Green Acres East
(site plan revisions dated October 21, 2019)
Greenfield, Project #2019-05

Green Acres East, Greenfield
2019-05
November 21, 2019

Adam's Pest Control **Medina, Project #2019-08**

Adams Pest, Medina
2019-08
November 21, 2019

Current Site Plan

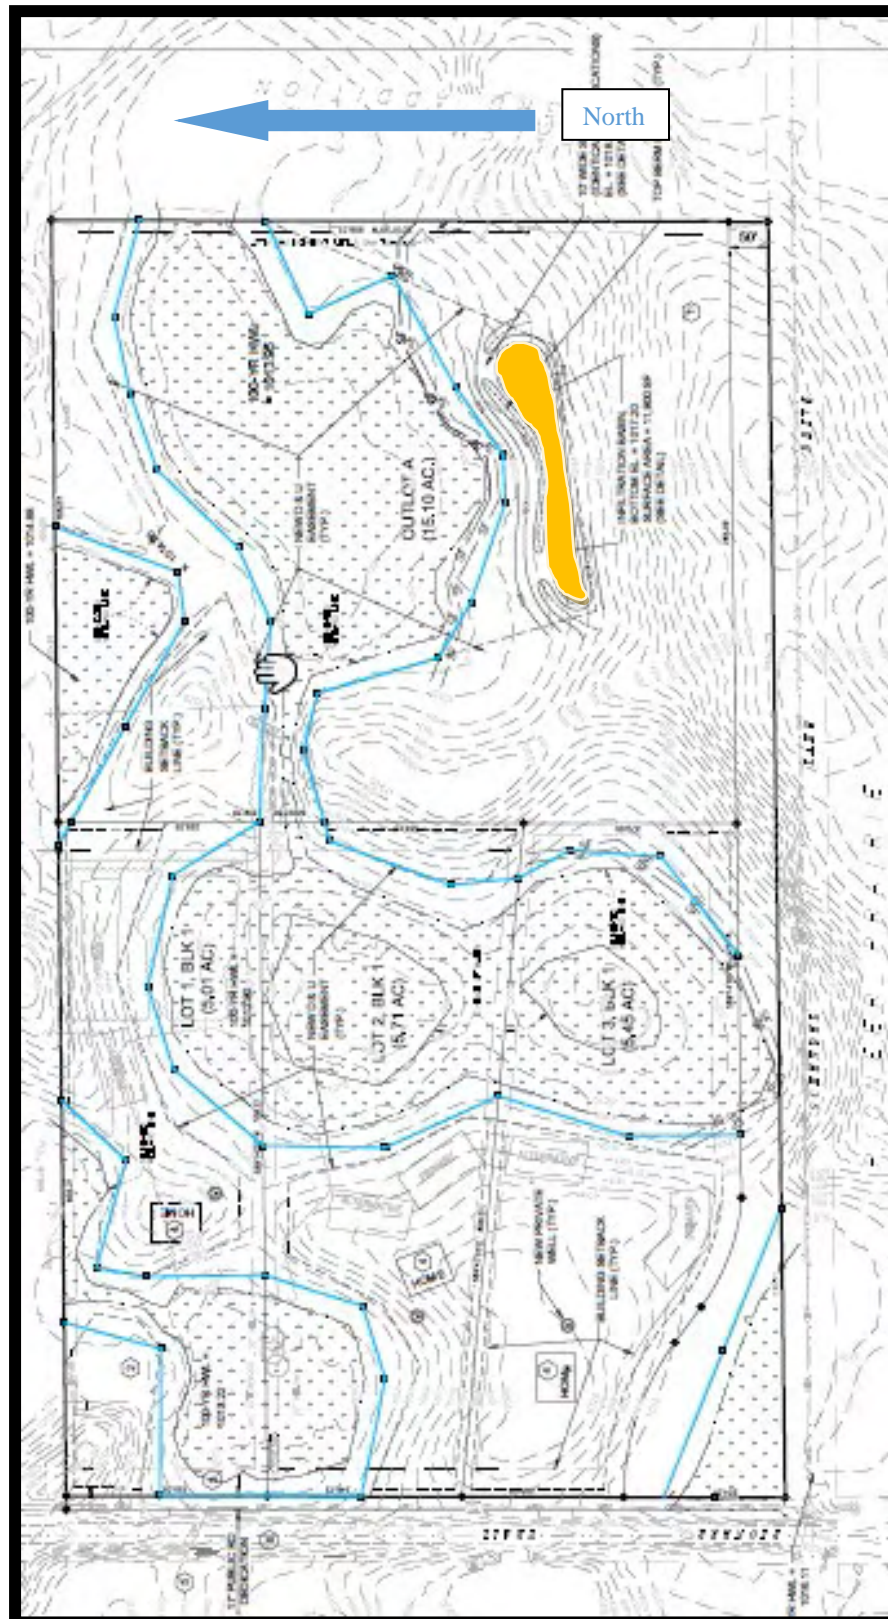
- 4) The 10/22/19 submittal is proposing to subdivide the parcel into three single-family residential lots approximately 5 acres each with a remnant outlot area of 15.6 acre in the east ½ of the site.

- 6) One infiltration basin is proposed to meet the Commission's abstraction, phosphorus and total suspend solids requirements.
 - a. New impervious areas on this site will be 2.19 acres.

Decision: Because of the decrease in the development scope, namely the plat consisting of only 3 lots and the elimination of the wetland impacts and road construction, staff believes the intent of the original approvals (stormwater management, easement and buffer establishment and erosion control compliance) by the Commission are still met. Staff approves the new plan set dated October 21, 2019 with the revisions to original conditions as outlined below;

- 1) An operation and maintenance plan must be developed for the infiltration basin and approved by the City of Greenfield and Commission. The O & M plans must be recorded on the property titles on Outlot A (unless an HOA will be responsible, then it will be required in the HOA deed documents) and
- 2) No wetland impacts can occur until;
 - a. The LGU in charge of administering the MN WCA re-approves wetland replacement plans per WCA requirements prior to any impacts to the wetland.

Potential Future Site Plan & Original Site Plan

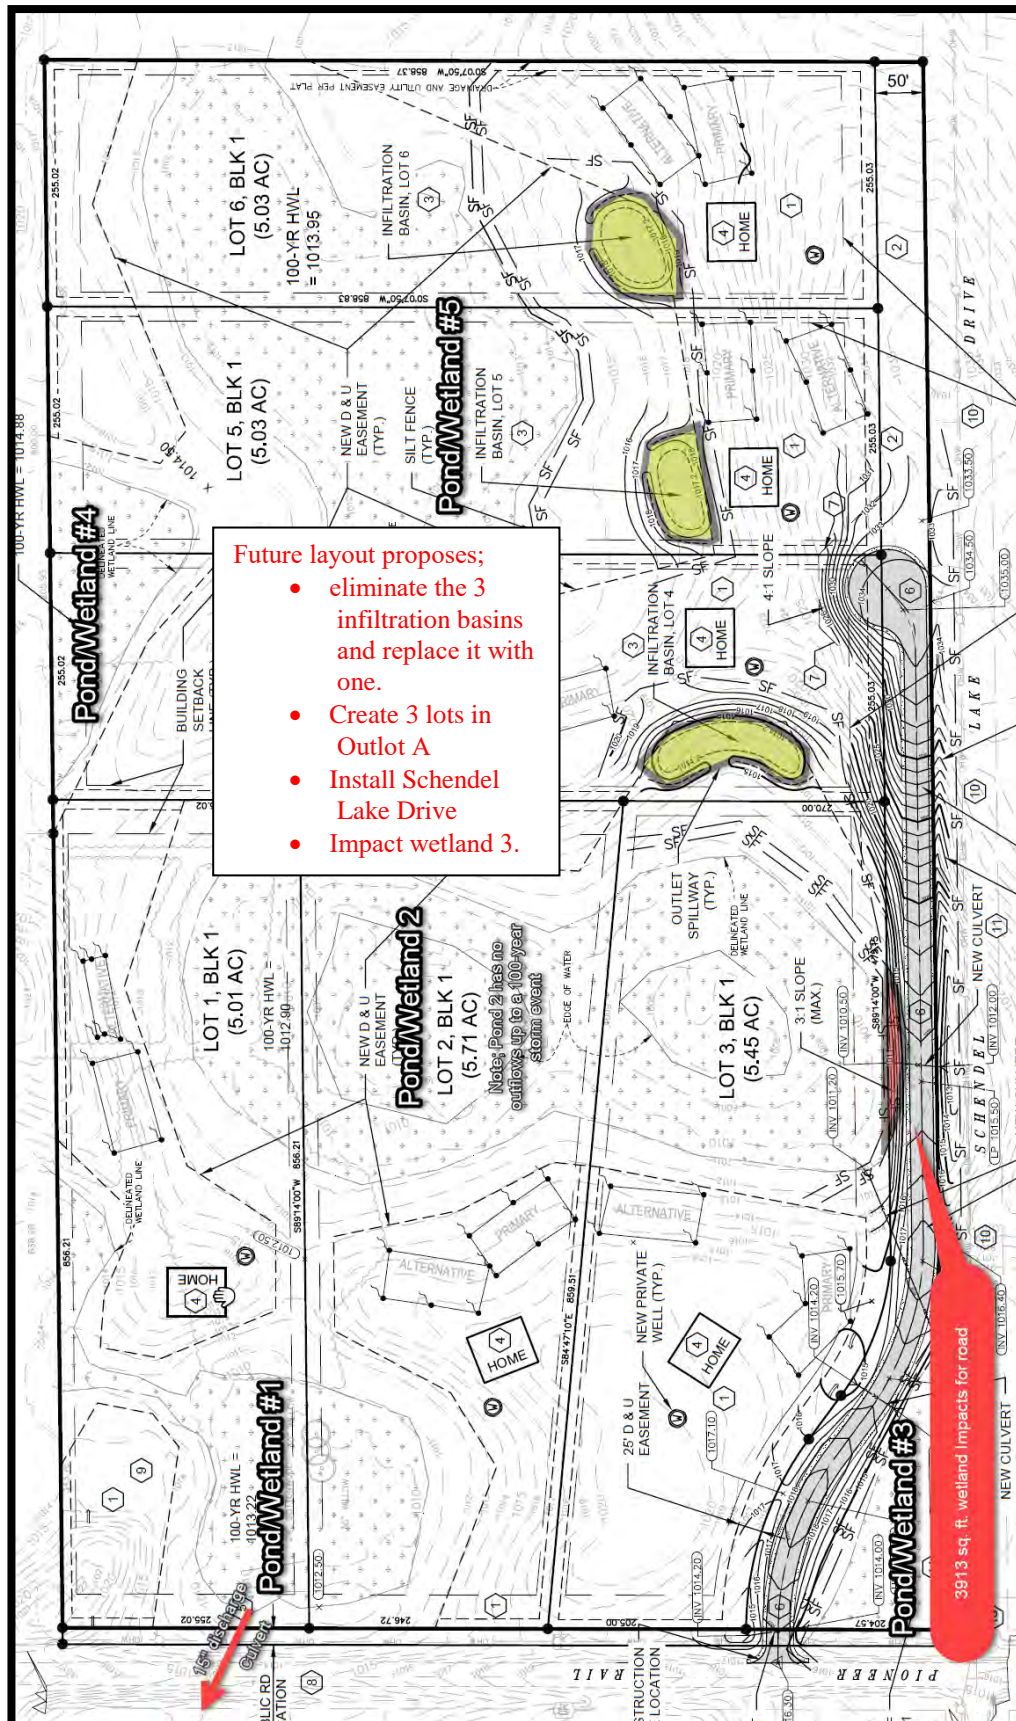
- 5) This site plan proposes three lots at approximately 5 acres each. Future plans will construct a road for access to east 15 acres in Outlot A. Three additional lots and an infiltration basin is proposed for that area when its developed in the future. Over all, with all six lots and the road work, site development will create 2.19 acres of new impervious areas. The October 21, 2019 stormwater management plan was designed for full development, including all 6 lots, wetland impacts and the new road areas.

16) In the previous plans, 3,913 sq. ft. of wetland impacts were proposed on wetland 3 from the construction of Schendel Lake Drive.

- a. Avoidance sequencing analysis based on previous plans (and ultimate buildout);
 - i. The proposed road alignment is necessary due to the city's desire to maintain connection with existing Schendel Lake Drive to the west and preserve the opportunity for future connection to Fern Lane to the east.

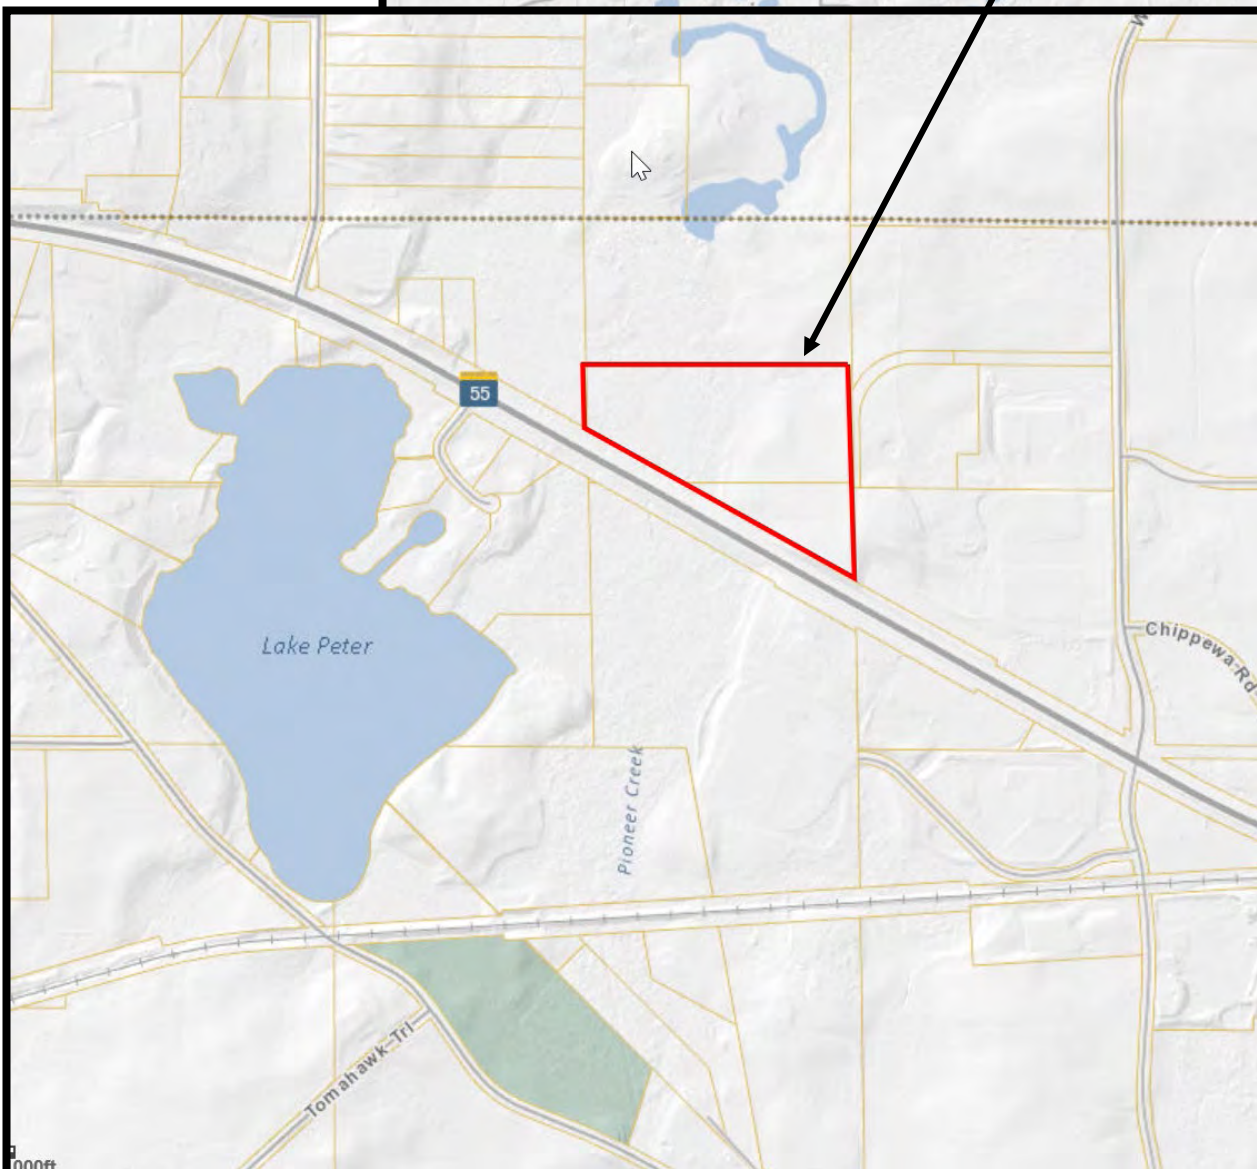
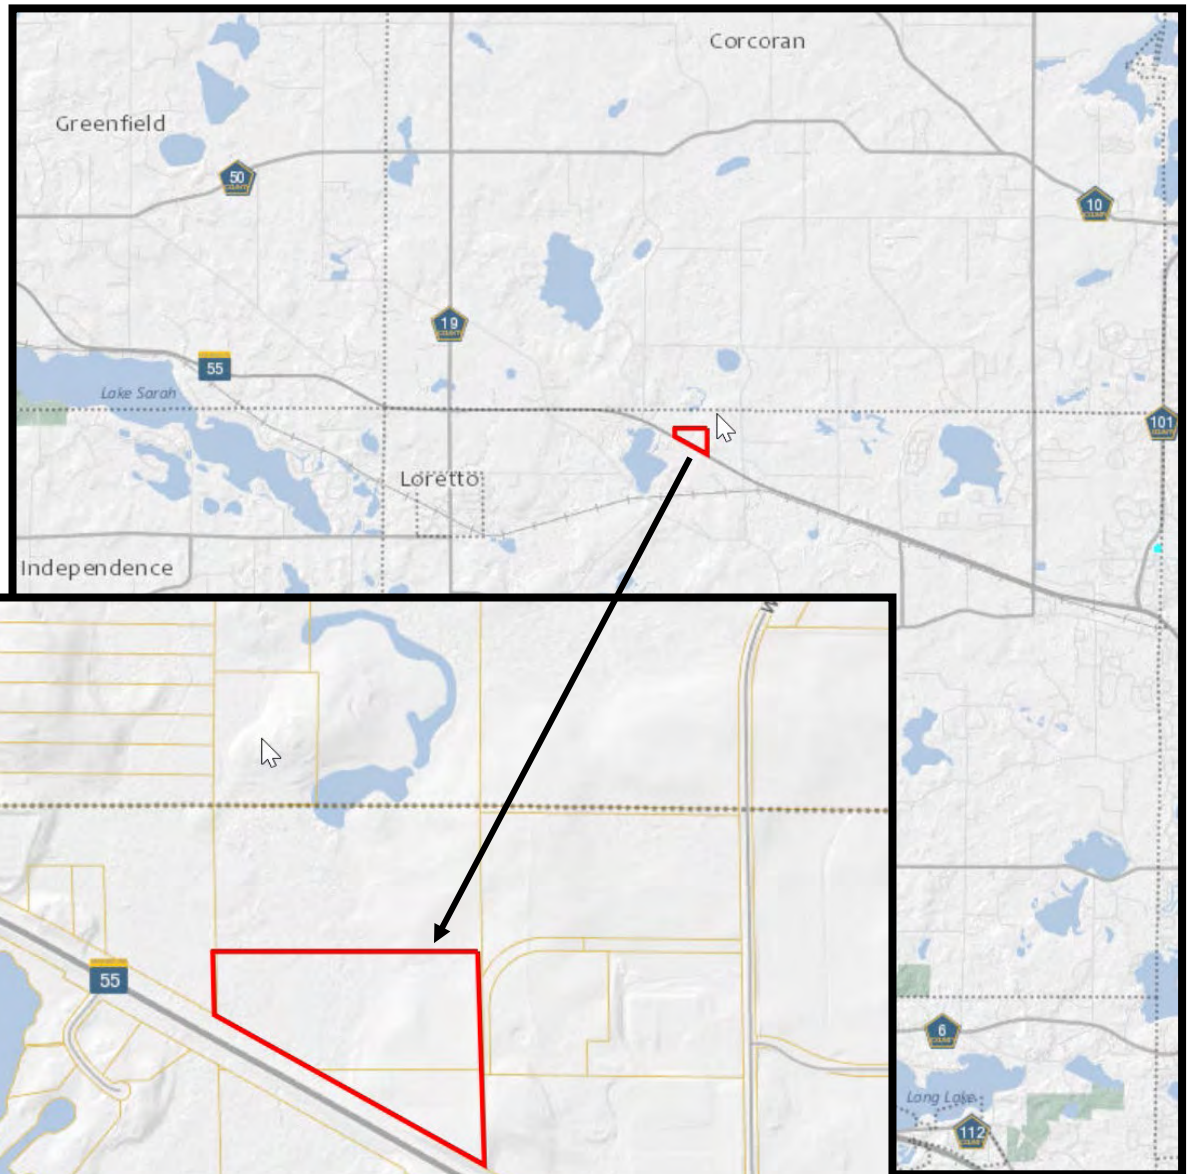
- 2) The current land use on the portion of this property being developed (21.58 acres) is wetland and cropland.
- 3) The applicant proposes to construct an office and warehouse building and its associated parking creating 4.59 acres of new impervious areas within the upland areas. Three filtration basins will be constructed for stormwater management.

- 7) Stormwater is proposed to be managed for rate, nutrient and abstraction controls by constructing three filtration basins on site. These basins will outlet into the existing wetland in the west portion of this property.

13) Wetland buffers are required on the large westerly wetland and the two wetlands on the north edge of the construction limits.

- 1) An Operation and Maintenance plan agreement for the stormwater facilities (sump manholes and filter basins) must be approved by the City and the PSCWMC and recorded on this property title. A copy of the recorded document, with the Hennepin County Document Number must be provided to the Commission
- 2) Construction sequencing details for the filter basins meeting the Commission's requirements,
- 3) Wetland buffer planting and maintenance plans must be provided for areas not in permanent vegetative cover.
